UNITED STATES PATENT AND TRADEMARK OFFICE

APPLICATION NO.	FILING DATE	FIRST NAMED INVENTOR	ATTORNEY DOCKET NO.	CONFIRMATION NO.
10/604,233	07/02/2003	Russell Bonaventura	LEAP:123US	1232
24041	7590	05/11/2005	EXAMINER	
SIMPSON & SIMPSON, PLLC 5555 MAIN STREET WILLIAMSVILLE, NY 14221-5406			NGUYEN, THONG Q	
			ART UNIT	PAPER NUMBER
			2872

Office Action Summary

DETAILED ACTION

Fig. 2

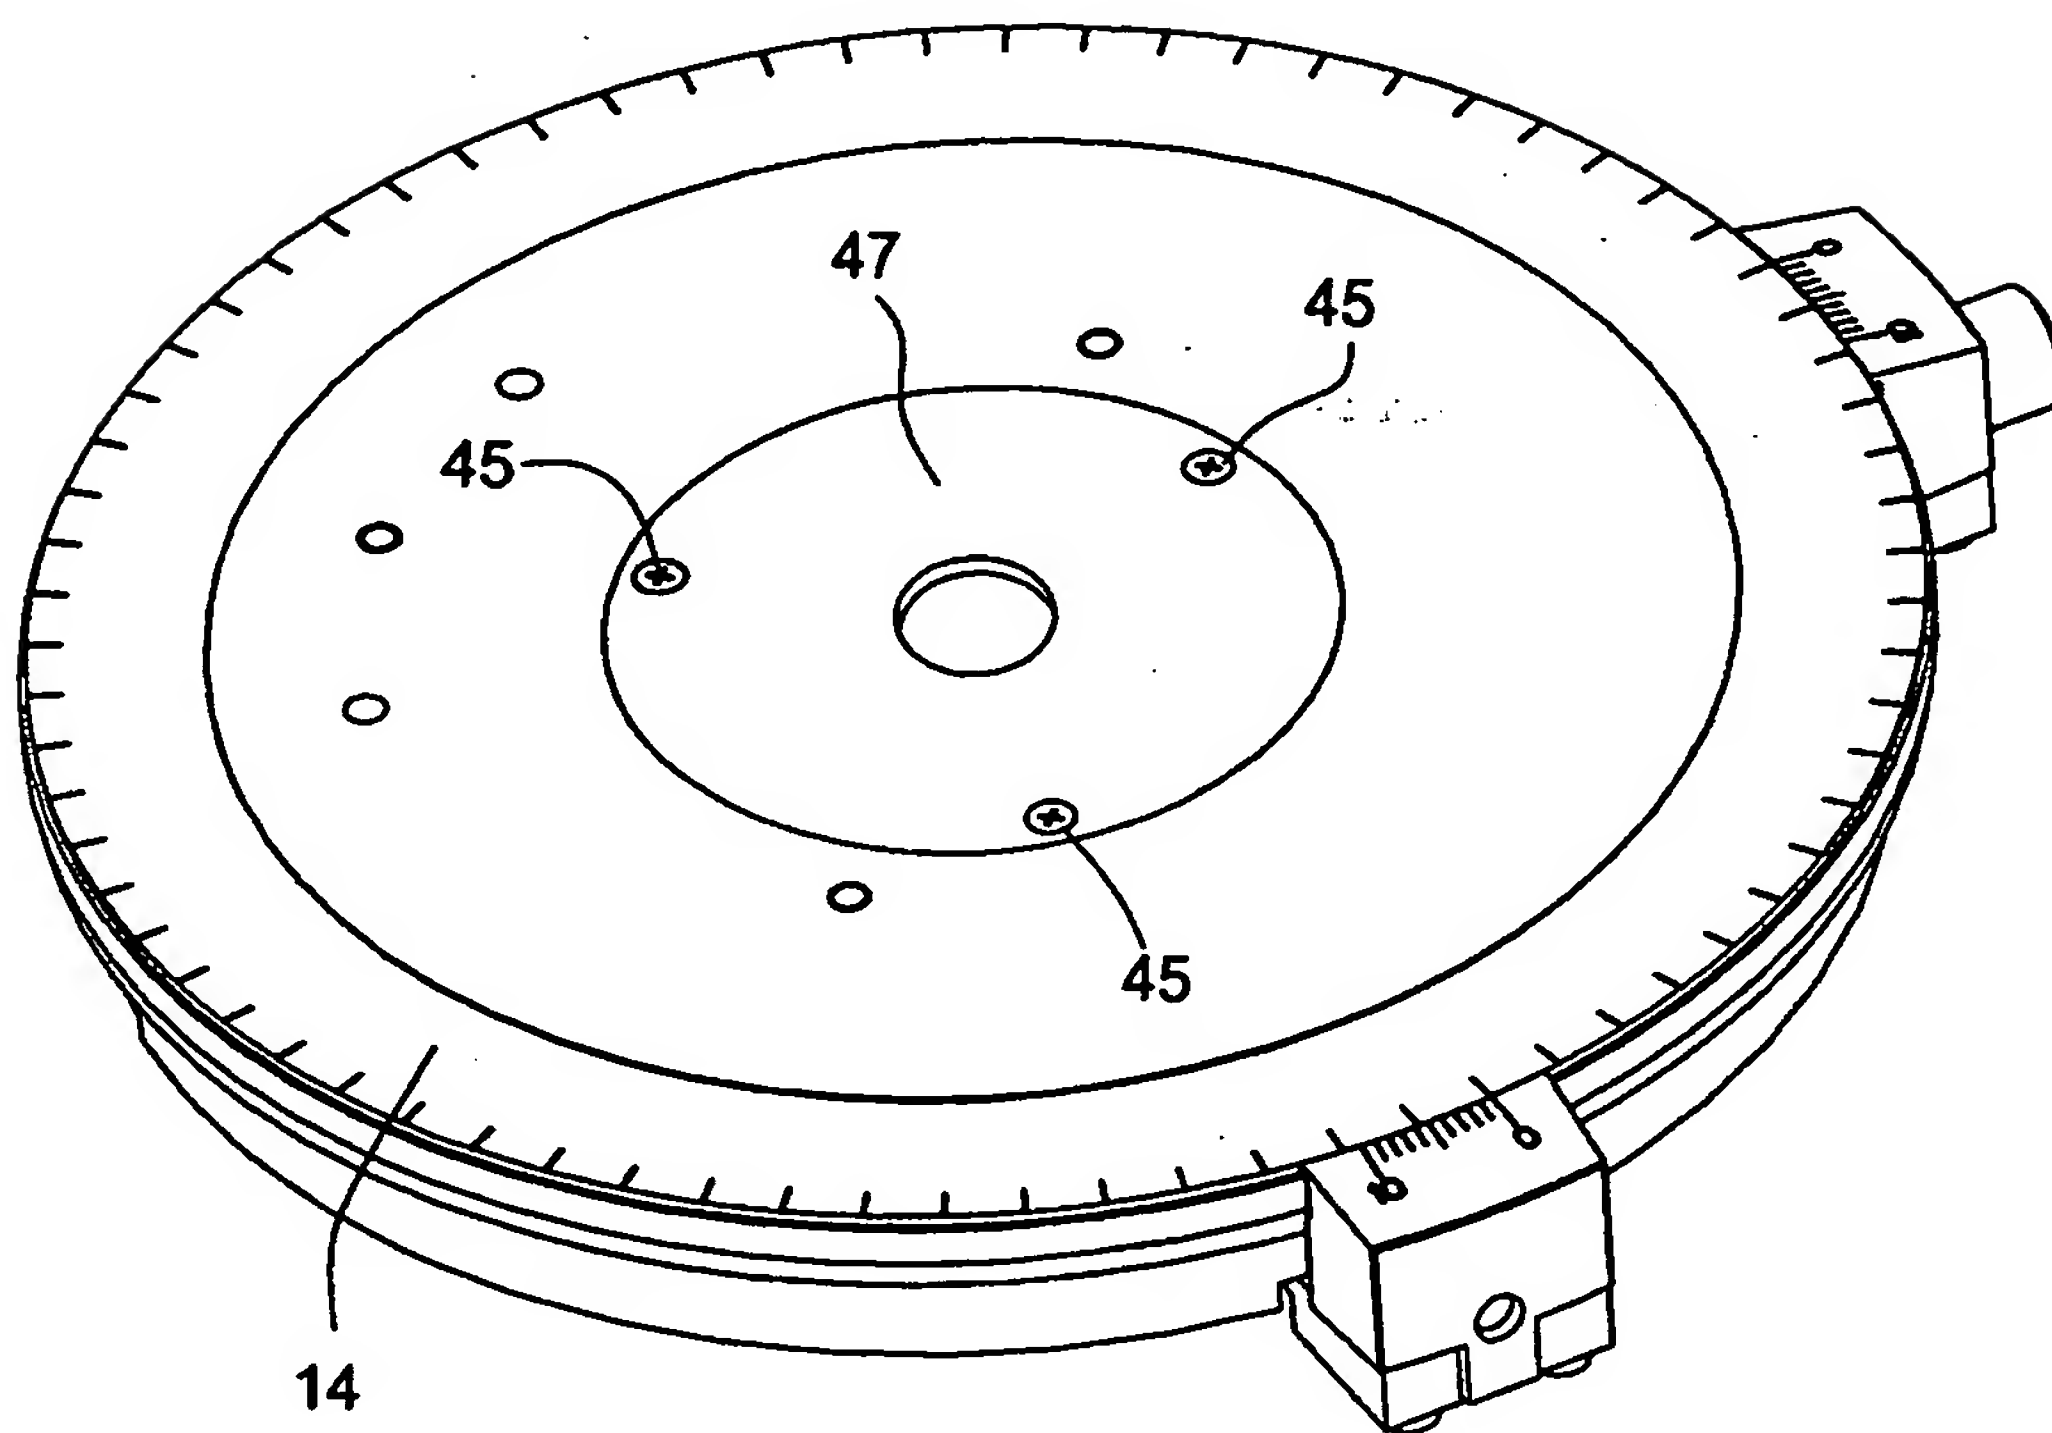
2. The drawing contained corrected fig. 2 was received on 2/16/05. The corrected drawing is approved by the Examiner.
